Technical Memorandum

Re: Response to Comments Regarding Potential Impacts of the Replenish Big Bear Project on the Lucerne Valley Land Discharge Location

Groundwater Wells at the Lucerne Valley Land Discharge Location

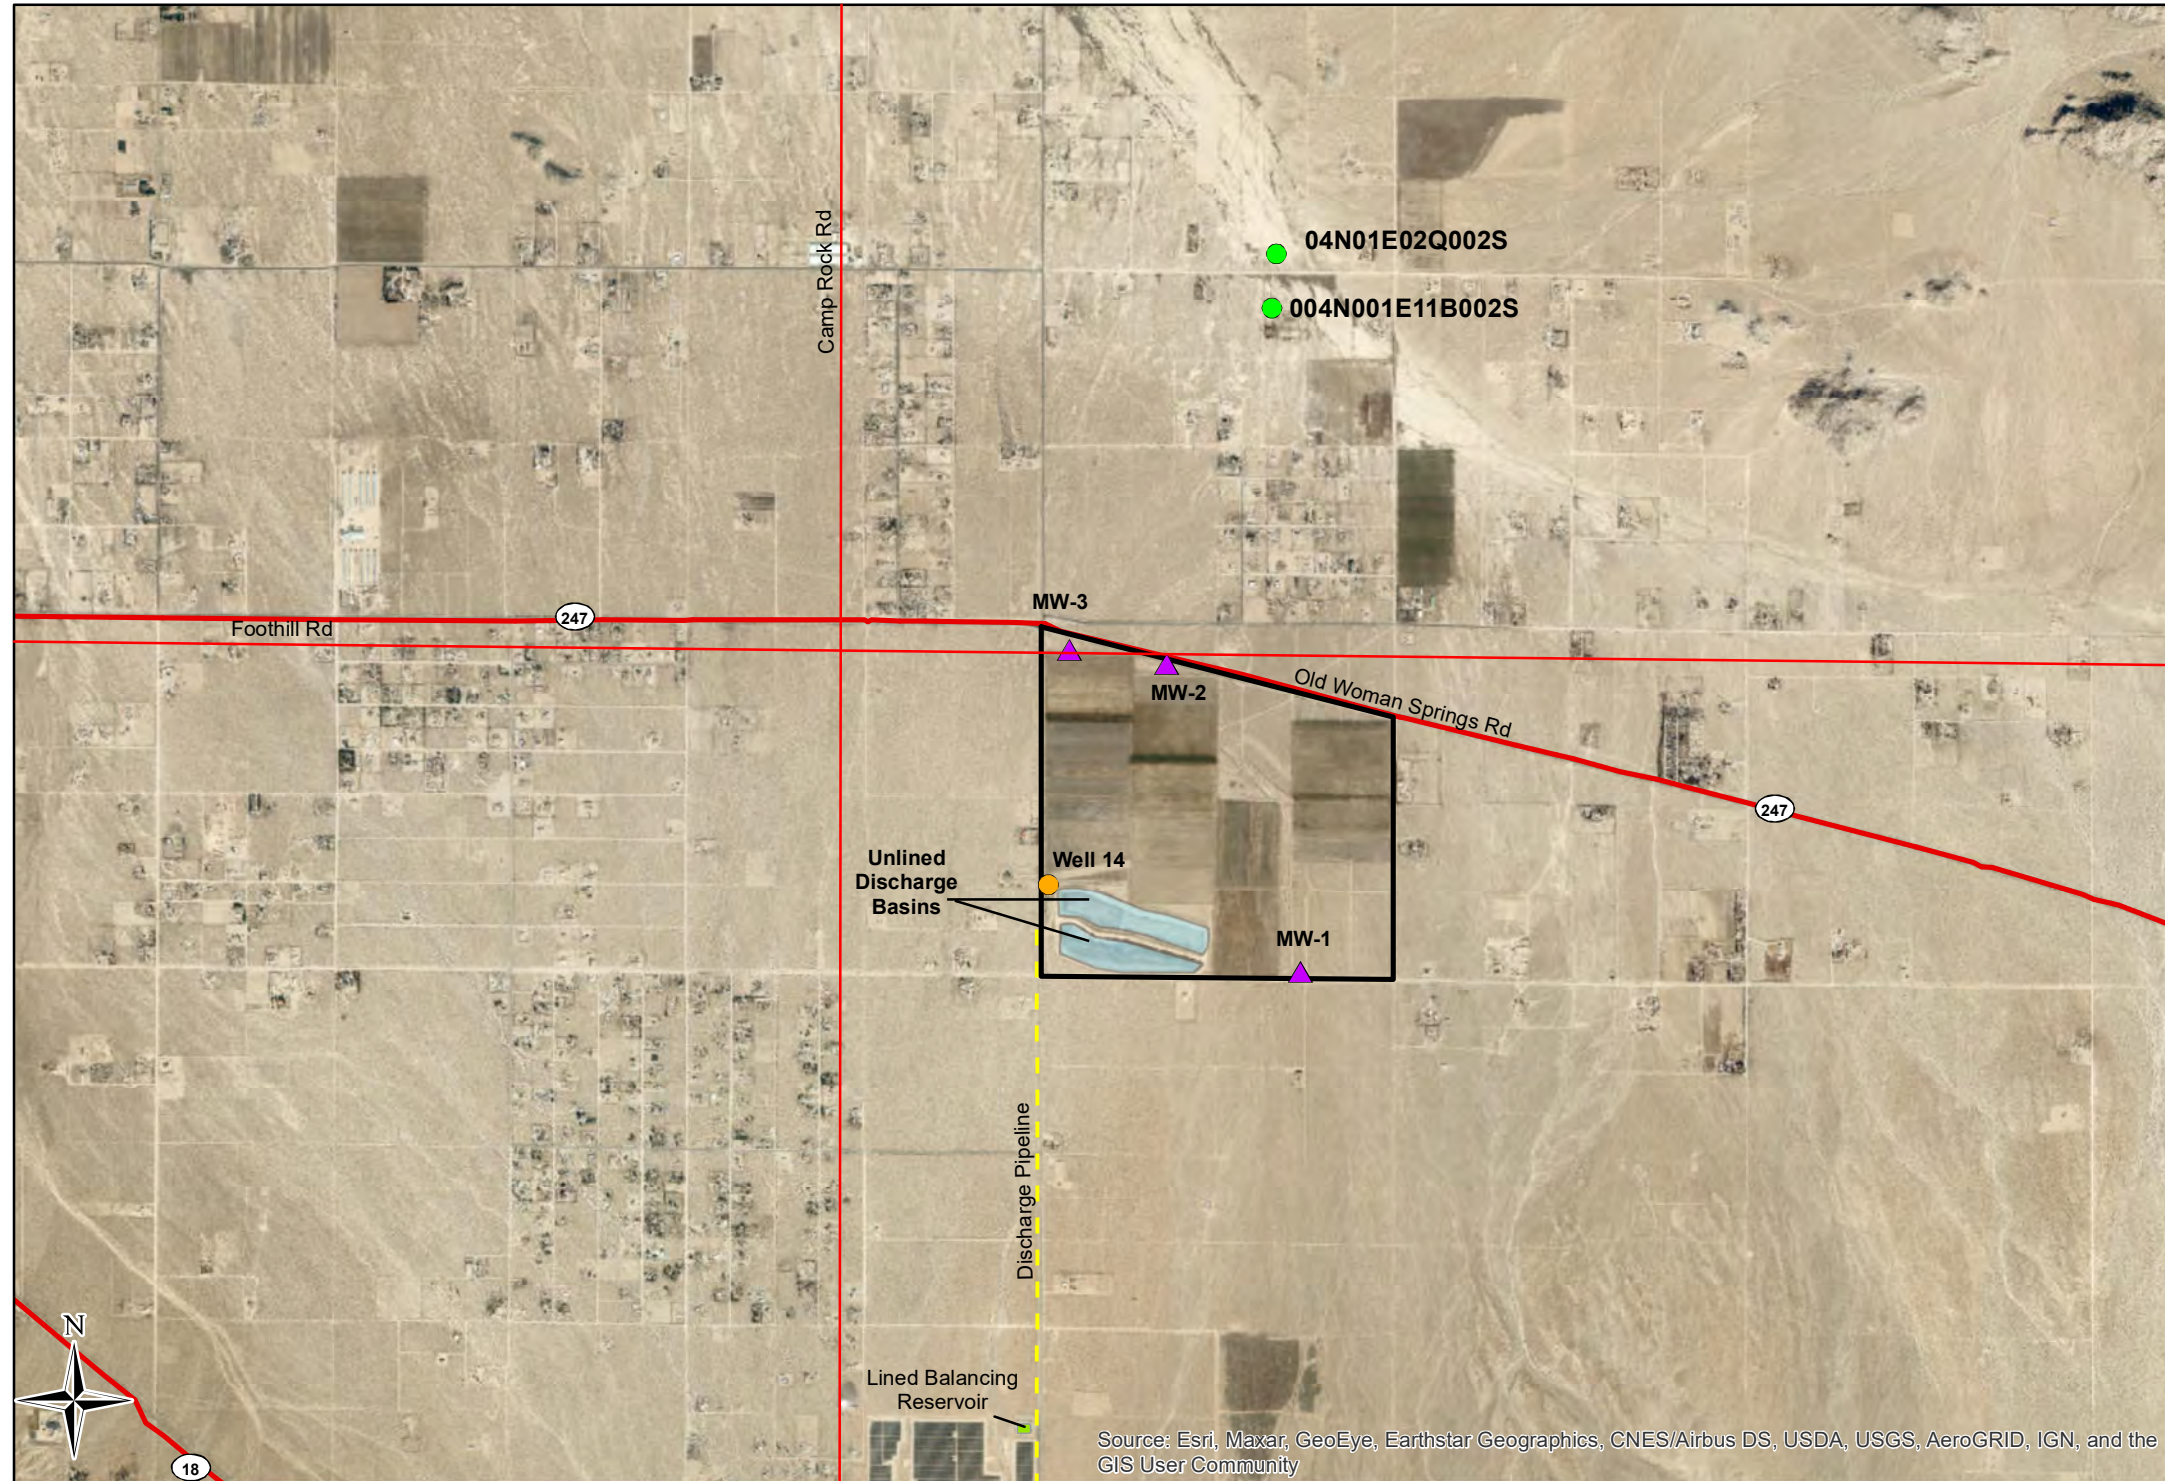
1. Have current and historical discharges to the LVDL contributed to surface or near-surface water flow in the natural wash located approximately 1-mile north of the site?
2. Have discharges to the LVDL caused higher Total Dissolved Solids (TDS) and nitrate concentrations in groundwater beneath the site than otherwise would have occurred absent the discharges?

Potential for Contributions to Surface Flow in the Wash North of the LVDL

It is assumed that the wash in question is the unnamed wash located approximately 0.8-mile northeast of the LVDL (see Figure 1). This wash is ephemeral, meaning that surface water flows in the channel only during periods of extreme above-normal precipitation. A review of historical aerial imagery (i.e. Google Earth) shows that this wash is dry in all historical images available since 1985 although its presence indicates that water has flowed in it periodically.

Based on a review of groundwater level data from wells located north of the LVDL and within or adjacent to the wash, it is not possible that groundwater recharge from surface discharges to the LVDL have caused surface and/or near-surface flow of water in the wash. Available

groundwater level records from 1994 through 2020 indicate that groundwater near the wash has never been shallower than approximately 110 feet below the land surface (see Figure 2). Records from two wells were obtained from the United States Geological Survey (USGS) National Water Information System (NWIS) online water database. Groundwater levels near the wash haven't varied more than approximately 10 feet and for the well with the longest period of record, was approximately the same elevation in 2020 as it was in 1994. As discharges to the LVDL were occurring throughout this time, and as there is no evidence groundwater levels have ever reached the ground surface at the wash, it is not possible that recharge from the LVDL has ever caused surface water flow in the wash.

Total Dissolved Solids Concentrations Lucerne Valley Monitoring Wells

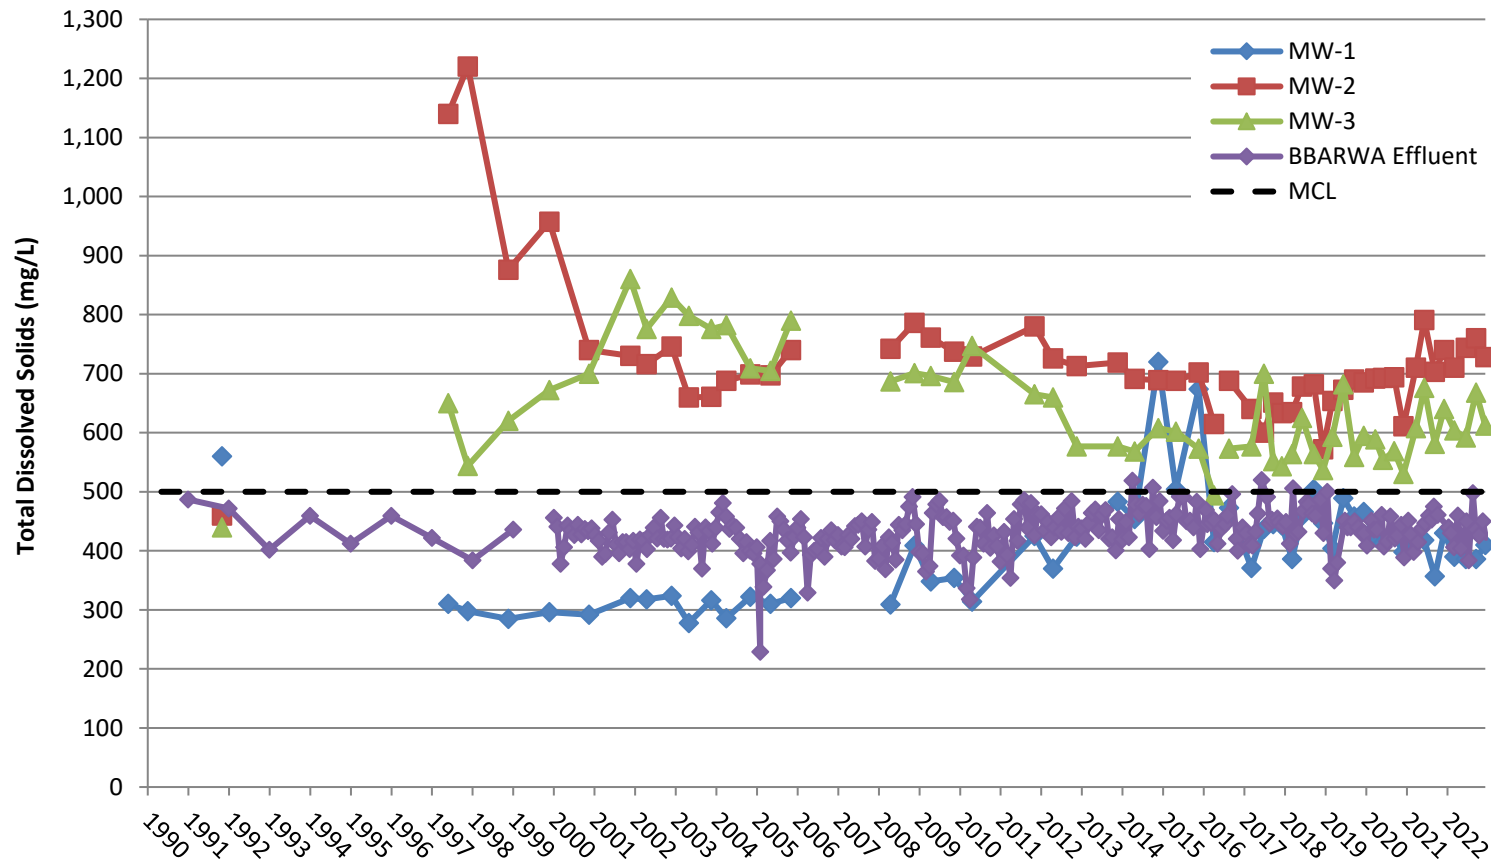
Potential for Groundwater Quality Impacts from BBARWA Discharges at the LVDL

TDS and nitrate concentrations in BBARWA effluent discharged at the LVDL have historically been lower than the TDS and nitrate concentrations detected in samples from the downgradient monitoring wells at the Site (MW-2 and MW-3).¹ Updated TDS and nitrate data in both the onsite monitoring wells and the BBARWA effluent since 2017 support the previous conclusion that the delivered water from BBARWA is not the source of the high TDS and nitrate concentrations in groundwater (see Figures 3 and 4). TDS concentrations in BBARWA effluent since 2017 show a slightly decreasing trend, while TDS concentrations in the groundwater from downgradient Monitoring Wells MW-2 and MW-3 show a slightly increasing trend (see Figure 3) suggesting the two are not correlated. Further, the downgradient concentrations are higher than the BBARWA effluent concentrations. From a mass balance standpoint, recharge of BBARWA effluent cannot be the source of the higher groundwater TDS concentrations. Similarly, nitrate concentrations in groundwater from all onsite monitoring wells are higher than concentrations in the BBARWA effluent. Thus, while the detection of low concentrations of nitrate in the BBARWA effluent contributes to nitrate in groundwater, the significantly higher nitrate concentrations detected in groundwater beneath the site indicates the BBARWA effluent is only a minor contributor and not the primary source.
